Re: Site Plan Application Review
Map 7, Lot 39 and 39-1
Warner, New Hampshire

On behalf of the Town of Warner (Town) Planning Board, Aries Engineering, LLC (Aries) prepared this engineering review of a Site Plan application for the property identified as Lots 39 and 39-1 on Warner Tax Map 7 (site) in Warner, New Hampshire.

RE: Jennesstown Manor Site Plan Application
Tax Map 7, Lots 39 & 39-1 – Warner

Our office is in receipt of the Aries Engineering review comments dated Oct. 20, 2025, and the Fire Department comments dated July 6, 2025. Based on the comments, we have made the required modifications and attached revised plans for review. A response to each comment has been provided below.

DATE: MARCH 25, 2025 SCALE: 1" = 40'
PROJECT NO: 24-0307-1 SHEET 11 OF 16

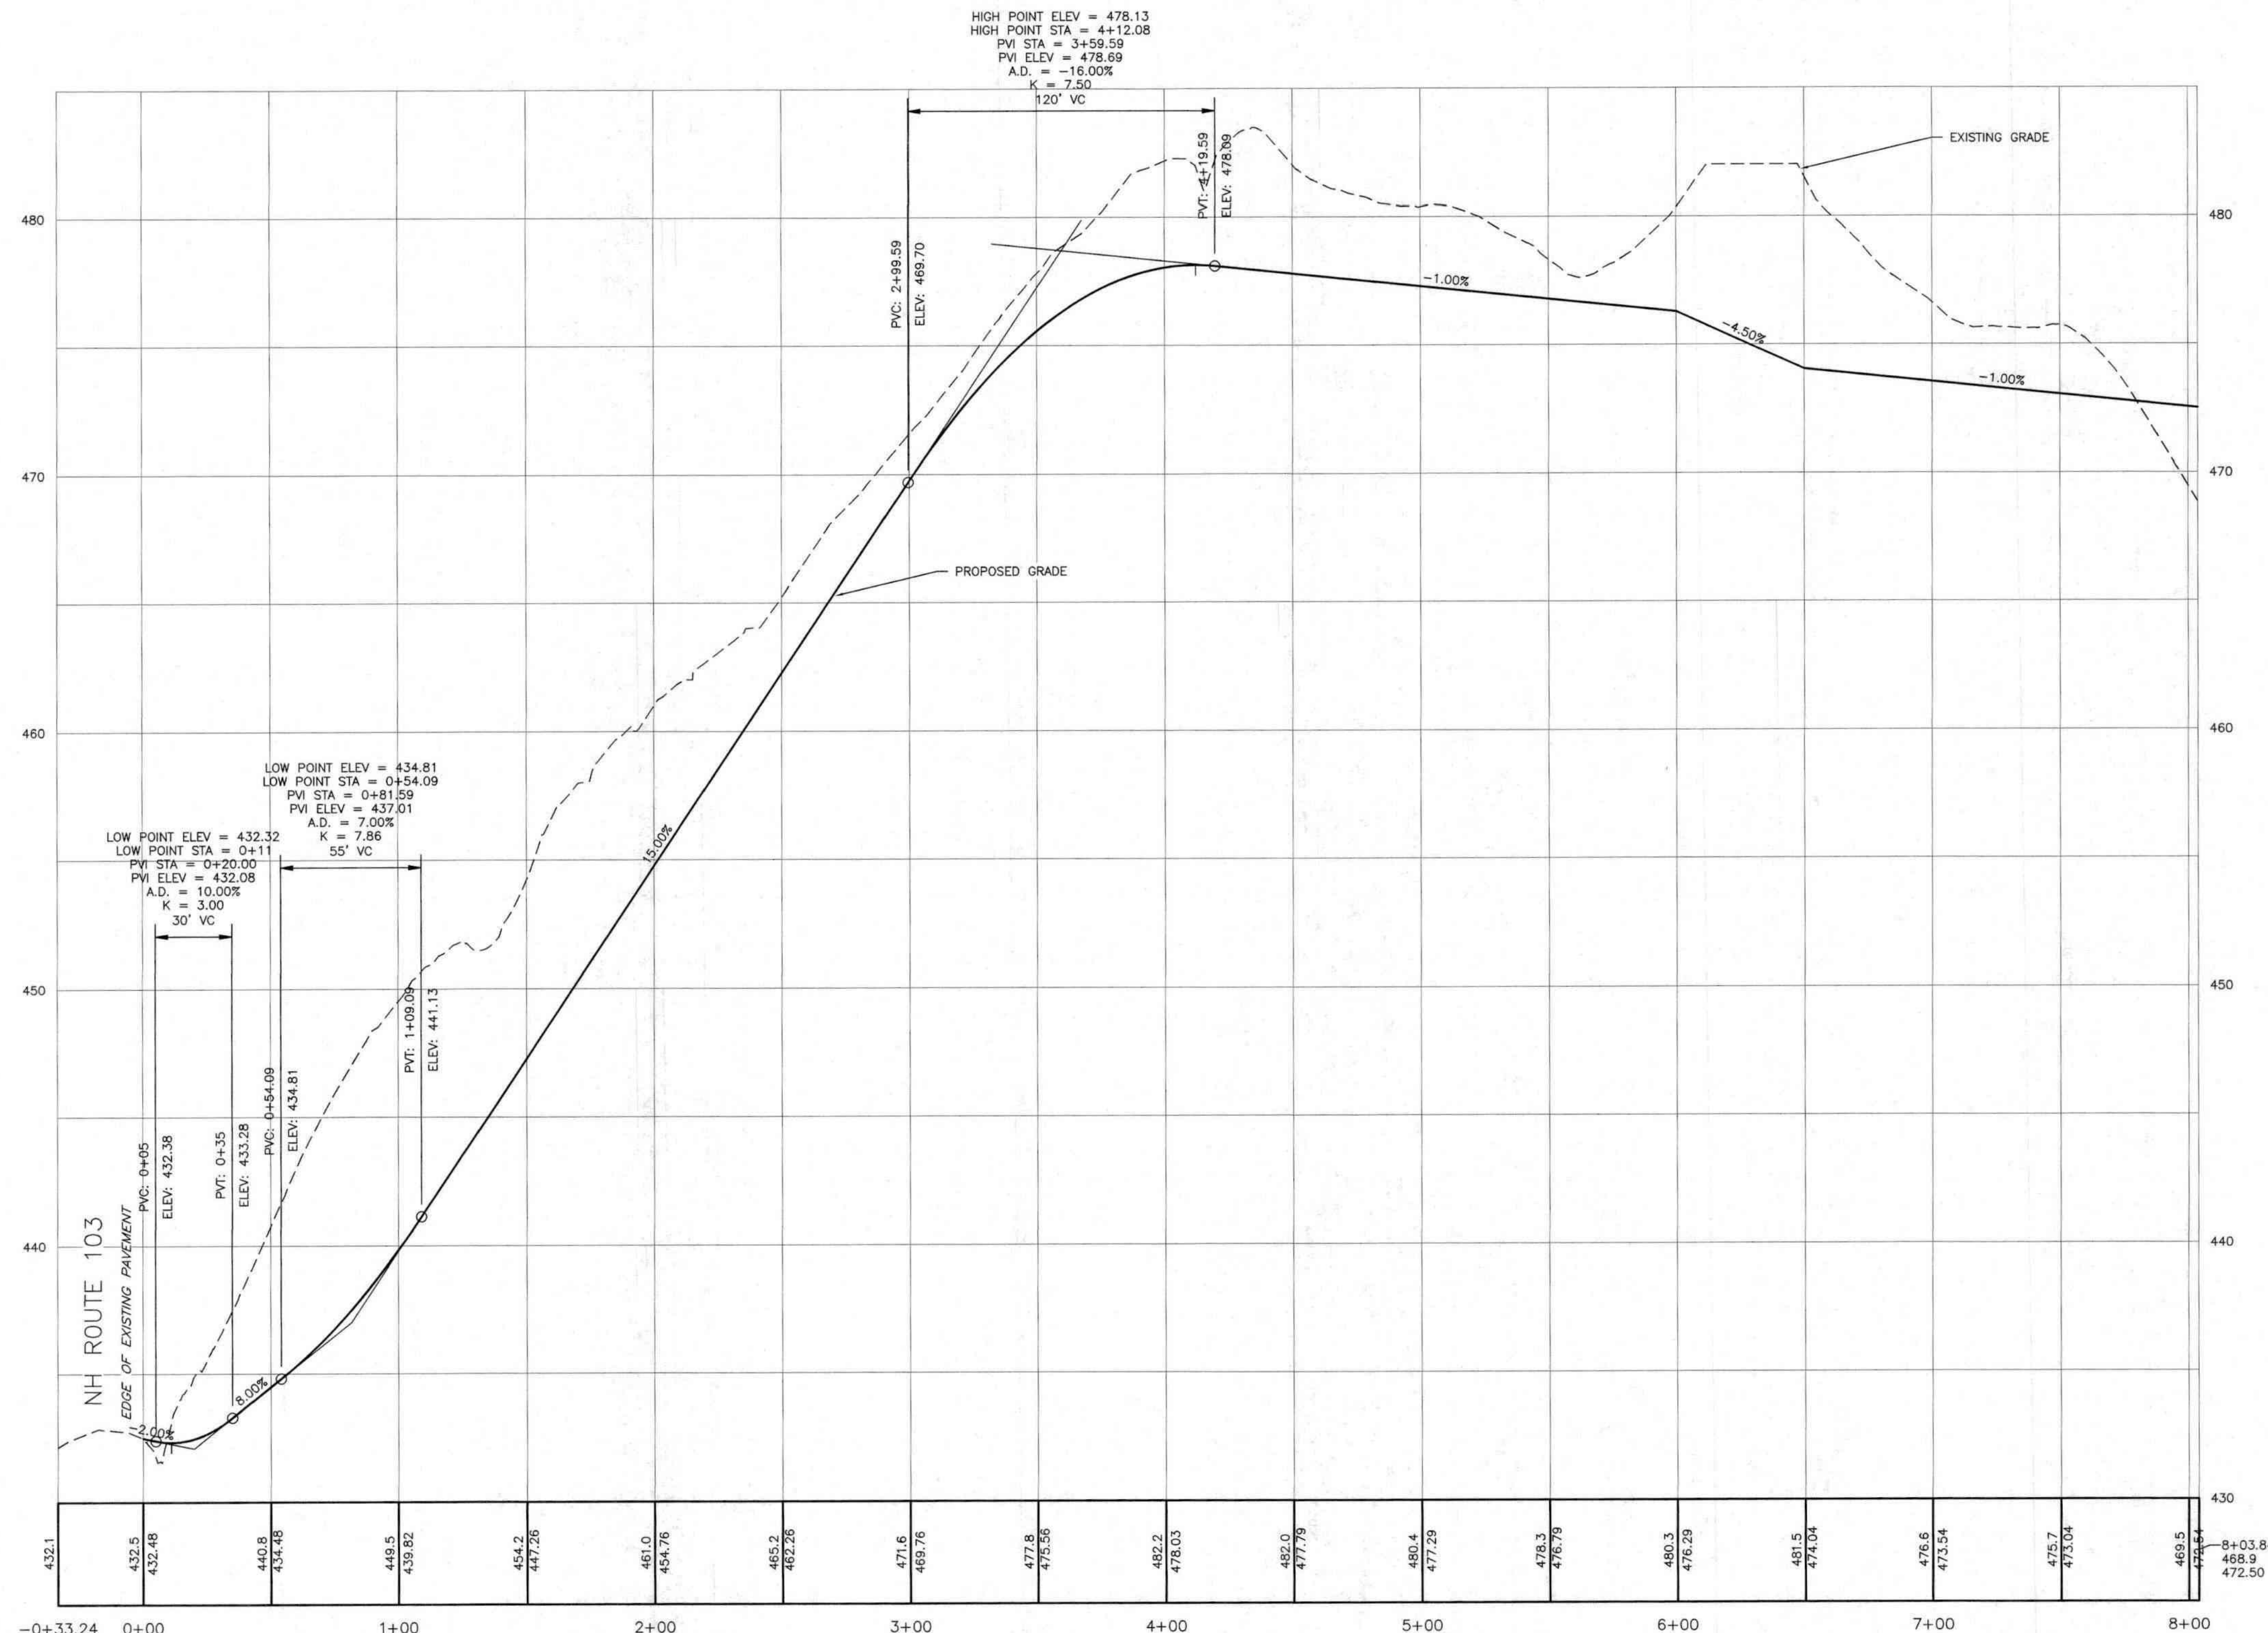
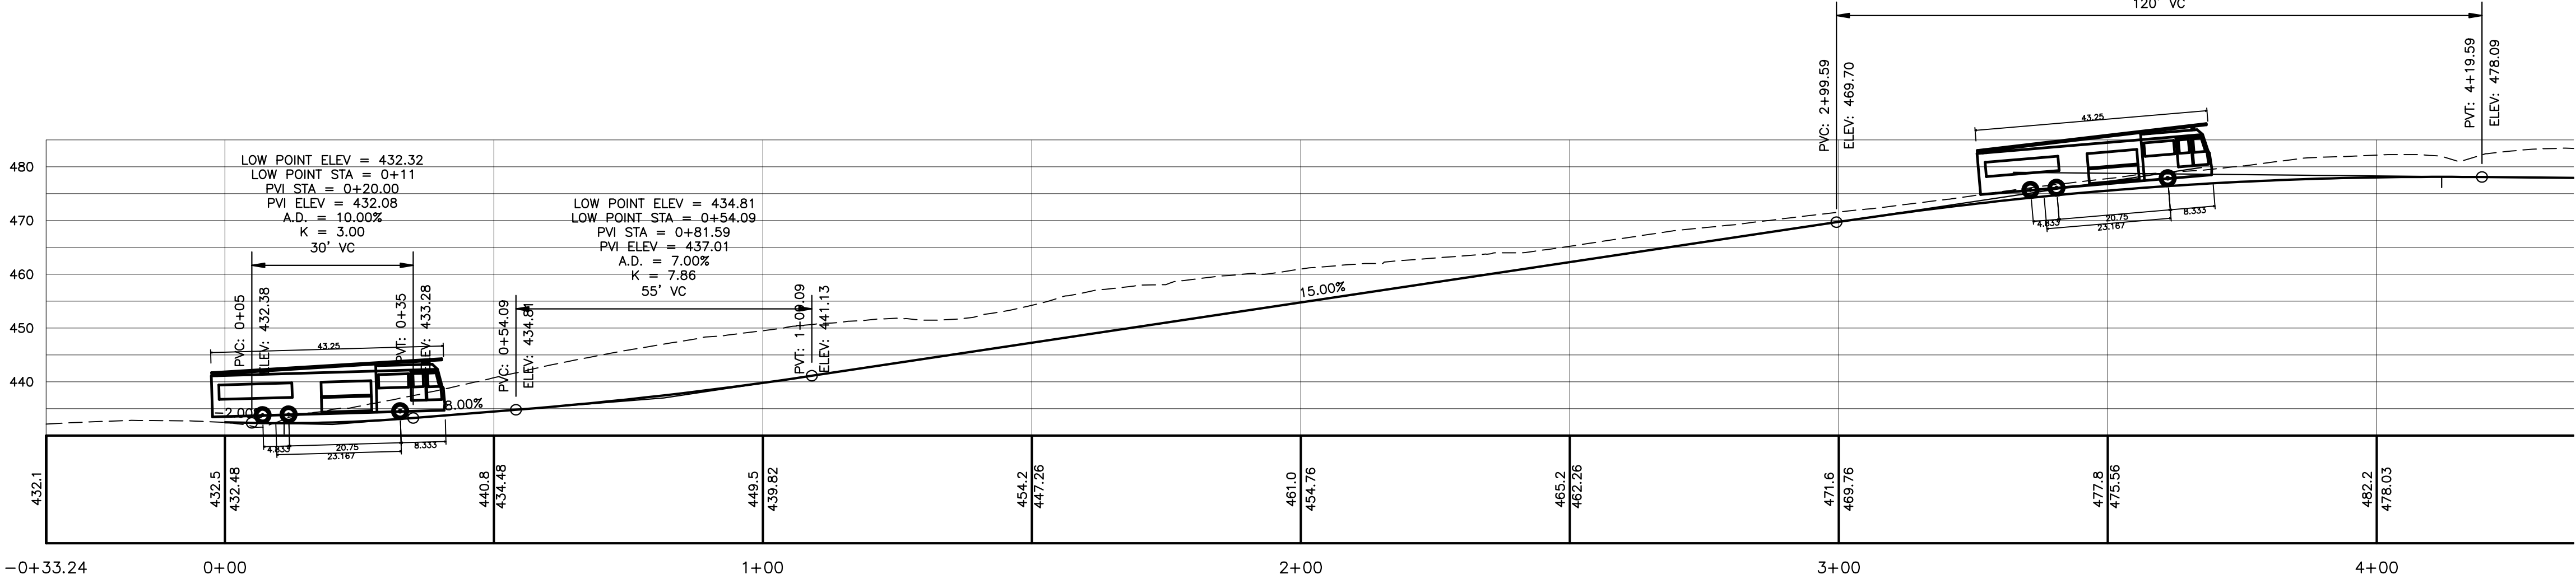
6. The site plans indicated an approximate access road starting elevation of 433 feet and a high point elevation of approximately 478 feet for the site access road, which is approximately 420 feet in length. The average grade is approximately 10.7%, while the majority of the access road is at a grade of 14.26%. Aries recommends that the proposed site access road be lengthened to meet the Section VII Design Standards grade of 10% for a local street for all portions of the access

We understand the concept of obtaining lower slope based on averaging the number but offer the following. The driveway is located on a state road under the jurisdiction of NHDOT. The edge of road is a fixed elevation. The NHDOT Driveway Policy requires the driveway to slope away from the road for drainage purposes. We also need to maintain a “flat” area for the vehicle to stop and assess approaching vehicles prior to entering the roadway. Due to the slope of the existing property the abrupt change in angle from a negative grade to a positive grade needs to be assessed. This angle needs to be analyzed for a proper vertical curve to transition for drivers comfort and physical limitation of vehicles with long bumper overhangs like fire trucks.

As can be seen on Sheet 11, the centerline profile of the driveway transitions from a -2% grade, to a +8% grade to a +15% grade. Between each change in slope a transition vertical curve has been added. This permits the appropriate platform adjacent to the roadway. To reduce the grade from 15% to the suggested 10.7% grade the point of vertical curve at the top of the “hill” would result in an additional 12 foot cut into the slope. This would also cause the structures to be about 10 lower. We have chosen to hold the 15% grade outlined in the driveway regulations to minimize the cuts and constructability of the project. No modification has been made.

OUTLET CONTROL STRUCTURE #41P DETAIL
NOT TO SCALE

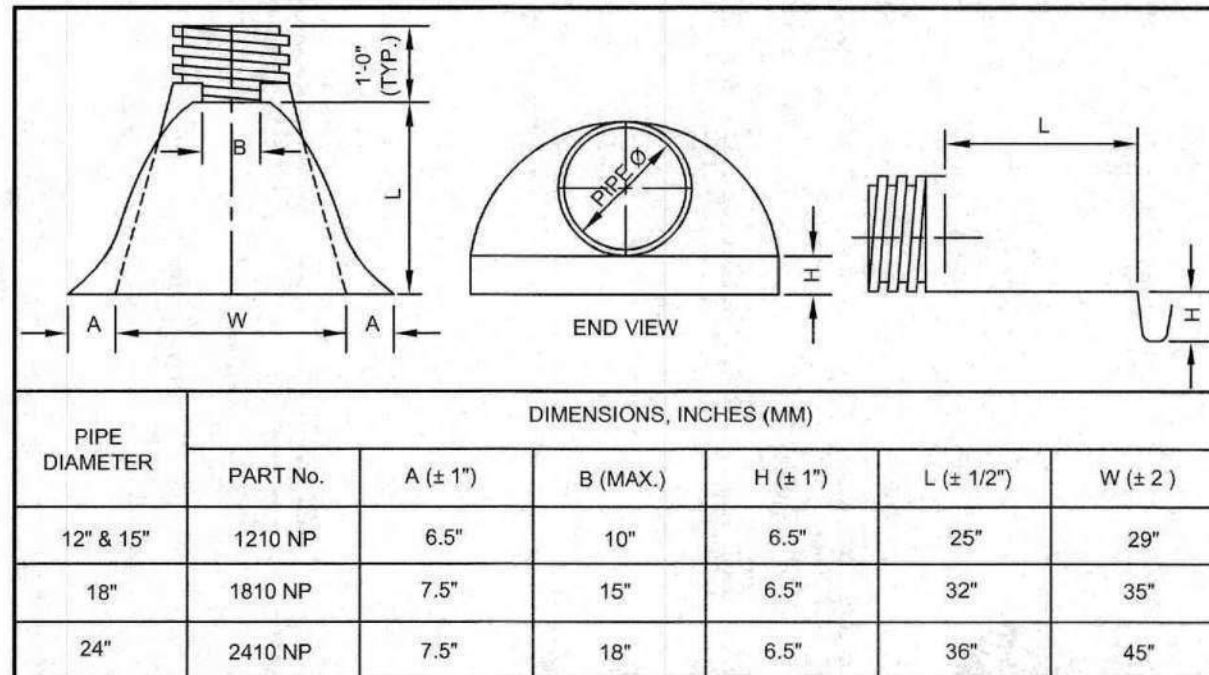
17. Lastly, the groundwater discharge from OCS#41 will increase the volume of water discharge to the State Right-of-Way (ROW), where it will flow to catch basing CB#4 and be directed beneath Route 103 through an existing 15-inch reinforce concrete pipe (RCP) culvert. This additional contribution of groundwater is not accounted for in the KNA drainage model and report. However, this additional discharge should not affect the northwesterly abutting property.

18. Aries recommends that the stormwater storage in Pocket Pond #41 be evaluated and redesigned to provide adequate stormwater storage and to mitigate groundwater discharge.

Groundwater discharge is a valid point. Groundwater will be dependent on subsurface water levels and seasonal conditions. Groundwater flow is factor separate from the storm event evaluated by the analysis. Groundwater is potentially flowing while it is not raining.

Based on an educated assumption about our design and the construction of Route 103, it can be suggested that the current subsurface groundwater flows toward Route 103. In 1953 Route 103 was constructed with underdrains on the south side of the highway that outlet into the subject catch basin, as shown in the NHDOT design plan below. Some of the groundwater flow will be intercepted by the underdrains, directed to the catch basin, and then outlet to the

What we know is groundwater outlets the pipe in the predevelopment conditions and will outlet in the post development condition. Again, groundwater flow is factor separate from the storm event evaluated by the analysis. But, based on the explanation above we know the Administrative Rules require the introduction of groundwater into the stormwater pond for proper function.

As previously outlined above, the design complies with the design requirements of NHDES Env-Wq 1500. Further the design has been reviewed by NHDES Alteration of Terrain and did not receive comments to revise the design. No modifications have been made.
